Avon Advisory Planning Commission Meeting  
March 23, 2026, at 6:30 pm  
at Avon Town Hall

## DPR 25-18: Walmart Market Avon Avenue

Planning & Building Department Staff Report

For Hearing on March 23, 2026

# Exhibit B2 – Revised Site Plan (11-March-2026)

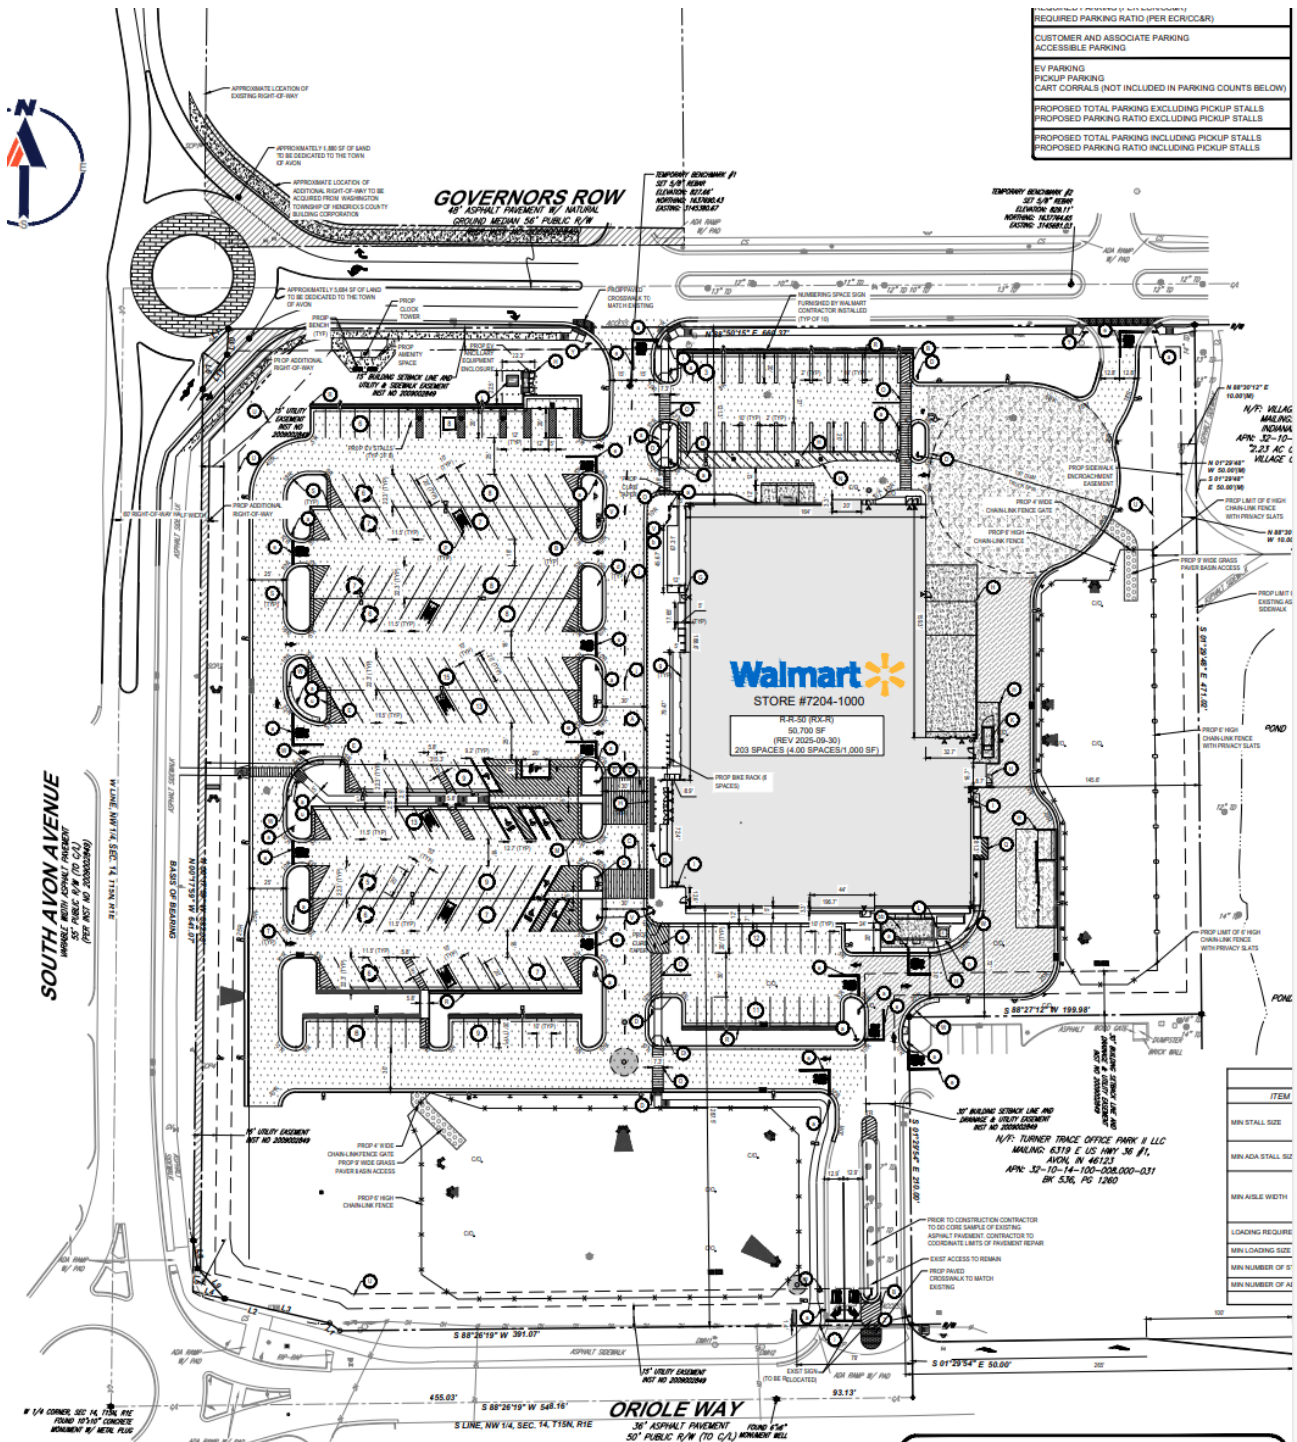
Revised site and landscape plans were submitted February 12, 2026 (see Exhibits B2 & C3) that address the issues raised by staff regarding bicycle racks, foundation plantings, interior parking lot landscaping, and the required site amenities. Additionally, more information was provided with the architectural plans to verify compliance with the glazing and roof requirements.

The revised site plan indicates a triangular median at the proposed Avon Avenue access point, which would be intended to prevent left turns to/from the site. A revised version of the petitioner's Traffic Impact Study (TIS) was submitted on February 9, 2026, which added a third scenario examining the proposed Avon Avenue access point as right-in, right-out only. Staff has consulted with the Department of Public Works and the Town's consulting engineer for review of the revised study.

c) **Bicycle Parking:** The UDO requires one bicycle rack per every twenty (20) required vehicle parking spaces, thus, six (6) bicycle racks would be required. While the revised site plan shows bicycle racks in a compliant location, the plan only indicates five racks. At least one additional rack would be required.

# Exhibit C4 – Revised Landscape Plan (11-March-2026)

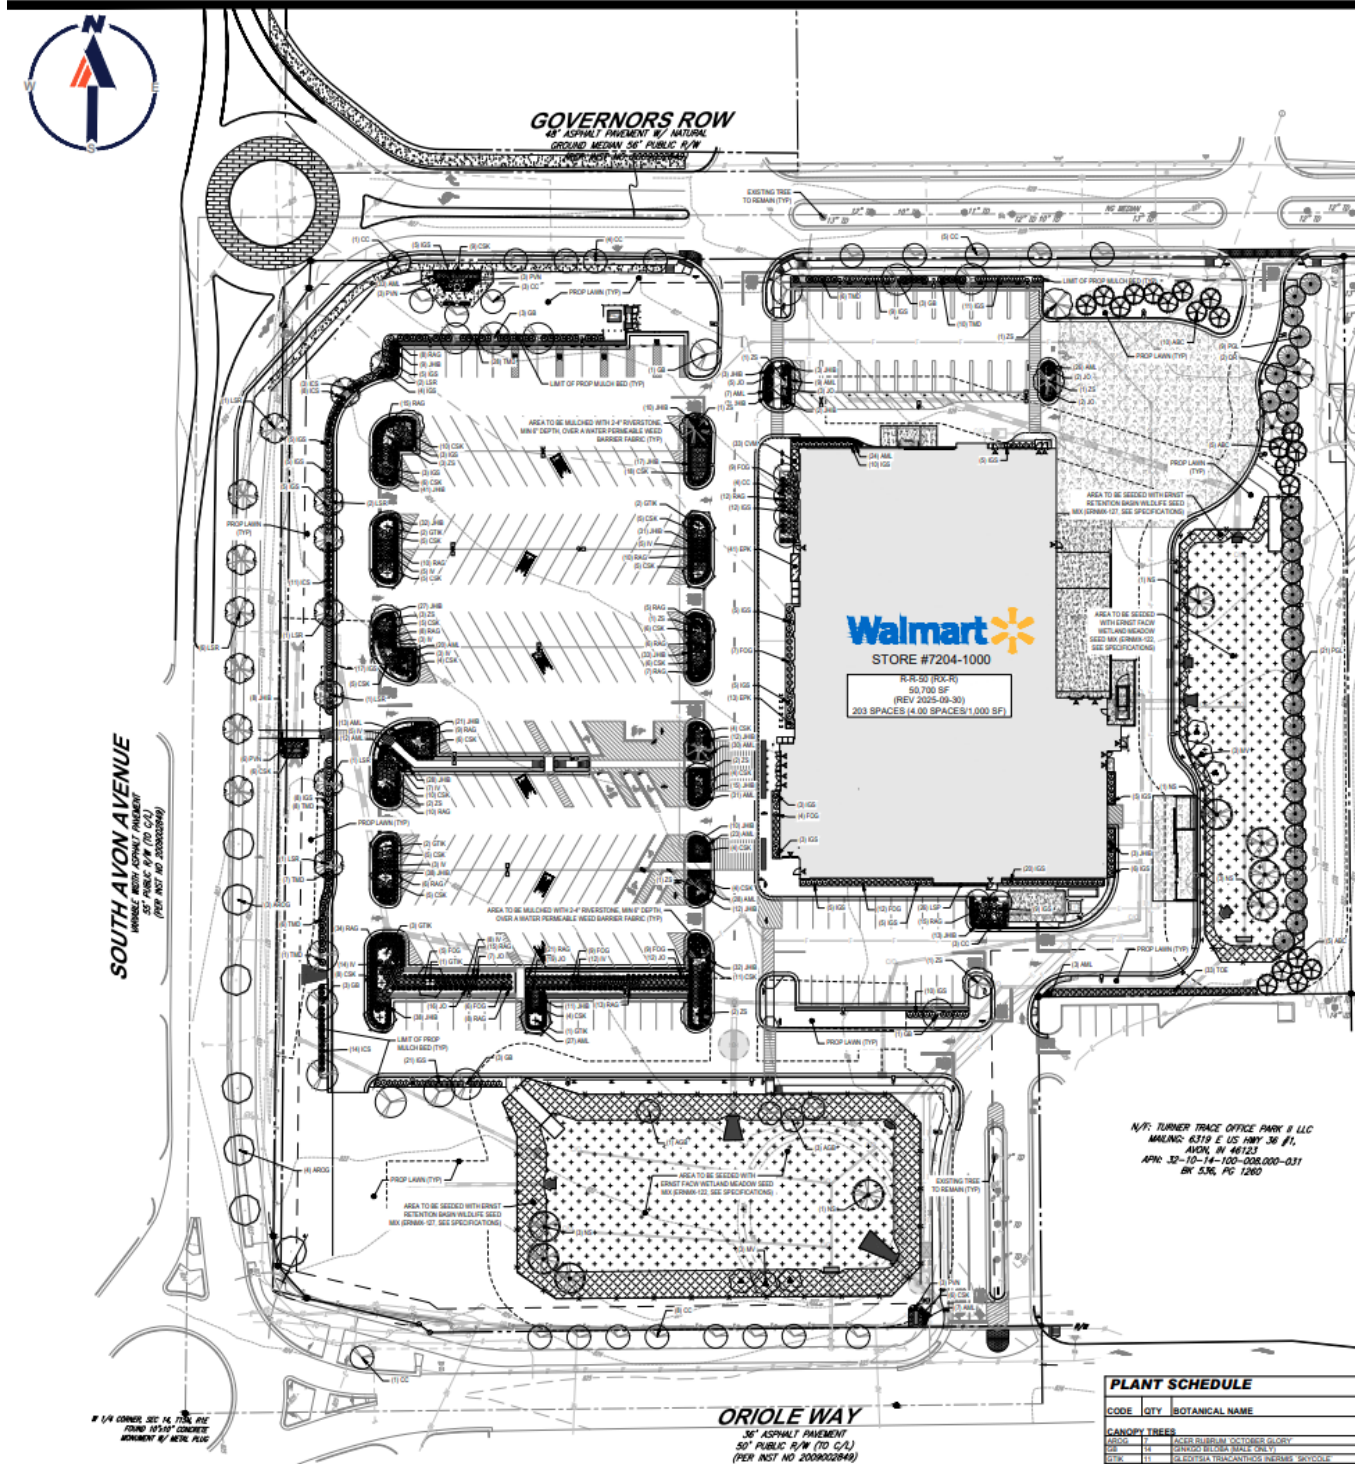
Per UDO 6.5 (A), a minimum five-foot planting area must be provided around the perimeter of the building, excluding access to the buildings, such as loading areas and doorways. The landscape plan submitted subsequent to TAC review has increased the proposed foundation planting areas, but is still deficient along several portions of the building (see Exhibits C1 & C2).

Per UDO 6.7(B)(4), each parking lot landscape island must have a minimum of one tree. The revised landscape plan is still deficient of this standard.

A further revised landscape plan should be submitted to demonstrate compliance with the foundation planting and interior parking lot landscaping requirements.

## Exhibit D – Proposed Building Elevations

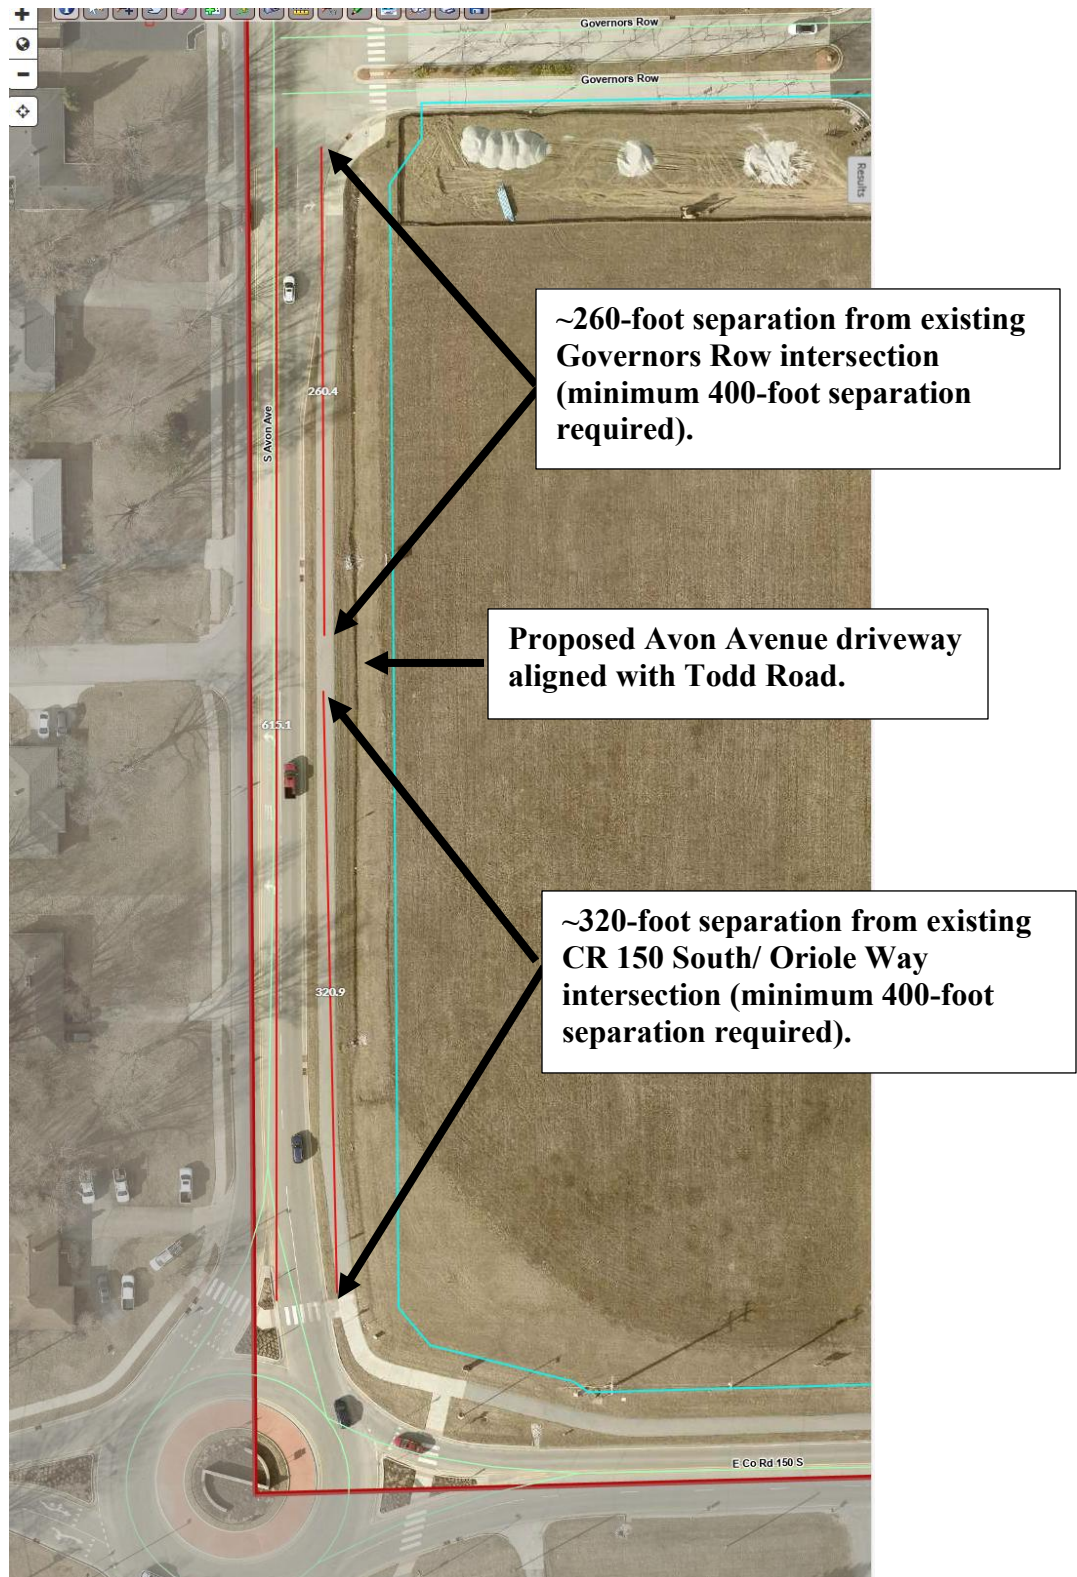
The revised building elevations, submitted subsequent to TAC review, appear to be deficient of several of the architectural standards (see Exhibit D).

UDO 7.10(D)(9) requires that the front of the building provide glazing on a minimum of 35% of the ground floor front façade. The elevations submitted do not provide dimensions and do not provide a calculation of the glazing provided. Staff's evaluation of the front façade has determined that 30% glazing would be provided. The petitioner would either need to provide revised plans or request a waiver.

UDO 7.10(E) requires that two of the five listed roof features be included. The revised plans indicate compliance with only one of these features.

The plans do not indicate compliance with UDO 7.10(H) which requires provision of two of the listed amenity options in order to contribute to the establishment and enhancement of community and public spaces. Plans should be revised accordingly.

# Exhibit F – Lighting Plan

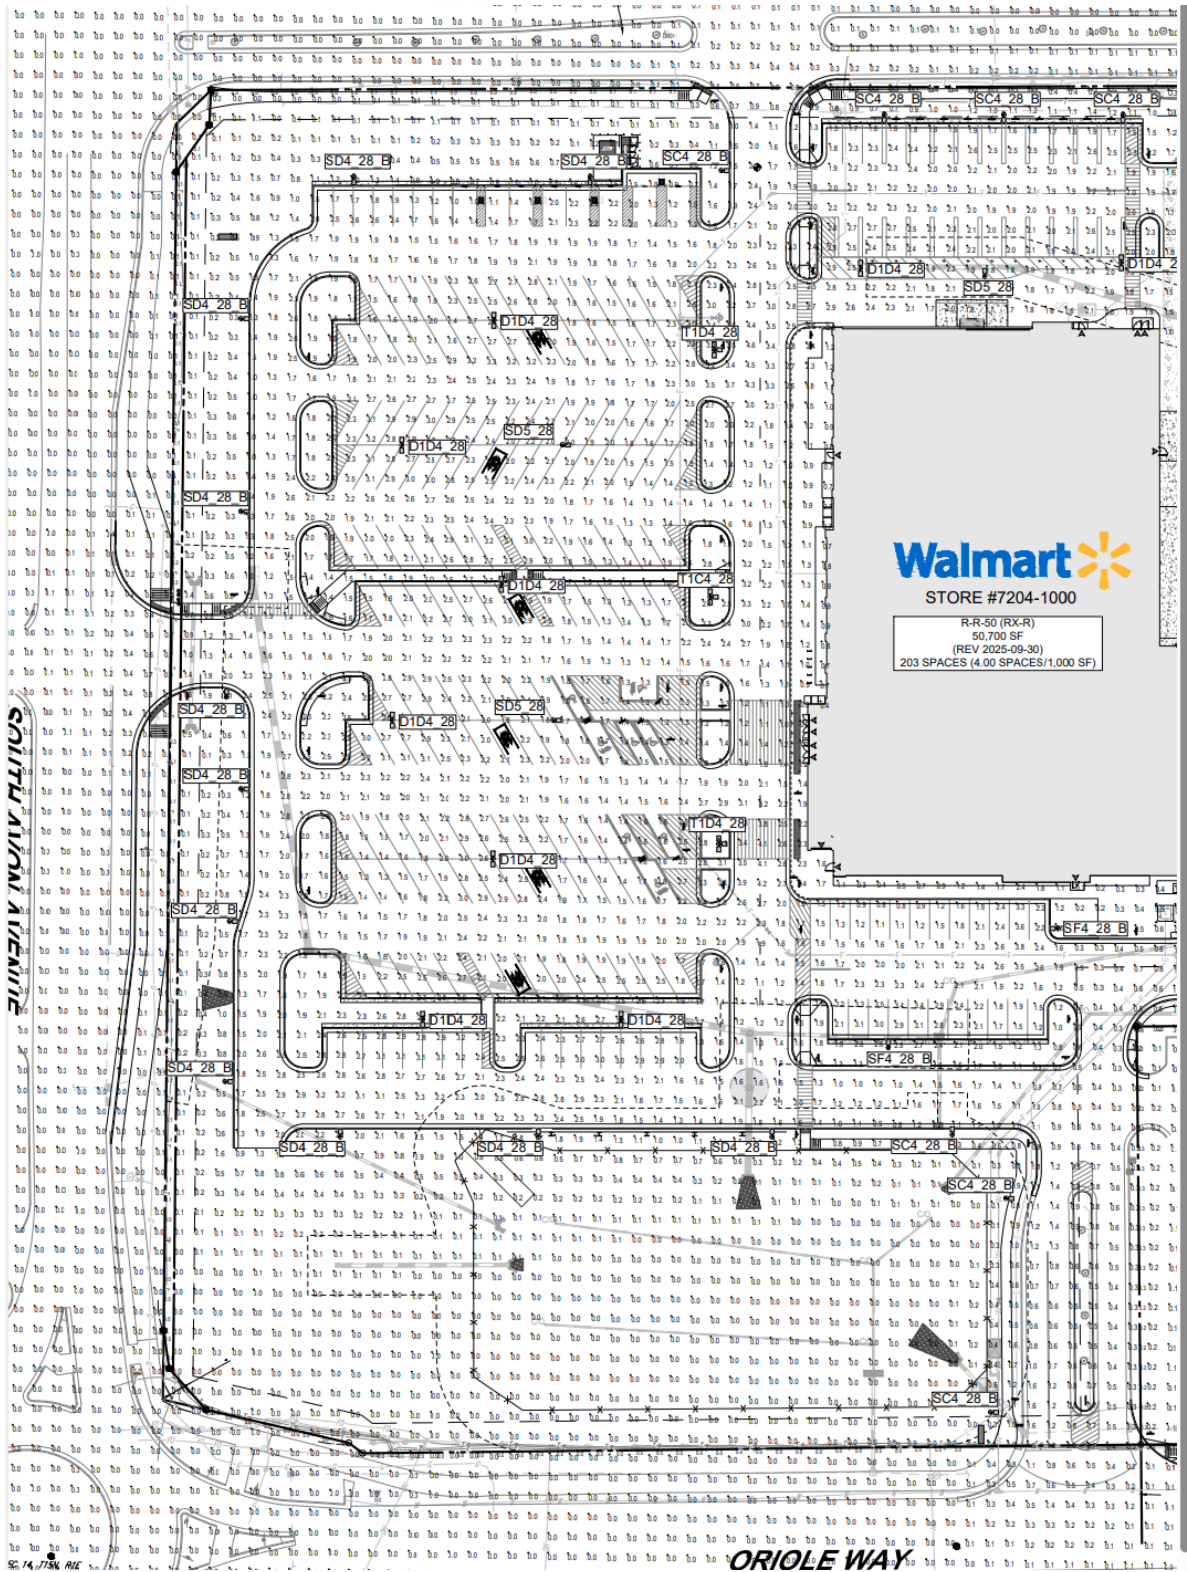
Two waivers of development standards have been requested to allow for excessive parking lot lighting and excessive light spillage into rights-of-way (see Exhibit F), which is discussed later in this report.

Waiver of Development Standards of UDO 6.10(C), to allow an average parking lot lighting level of 2.16 foot-candles (Fc), which exceeds the 1.6 Fc maximum average allowed.

The Town's lighting standards allow for a range of lighting levels, and the 1.6 Fc maximum average is in line with the recommendation of the IES, which recommends an average lighting level of 1.0 Fc for parking lots in suburban settings. Excessive lighting adds to light pollution, which can have negative impacts upon the public such as diminishing the quality of night sky views.

Waiver of Development Standards of UDO 6.10(A), to allow light spillage of 0.4 foot-candles (Fc) into the abutting rights-of-way, which exceeds the 0.3 Fc maximum allowed.

Staff concurs with the petitioner’s assertion that this is a minor deviation, and the Town is generally not opposed to slightly higher light spillage at an intersection (see Exhibit F).
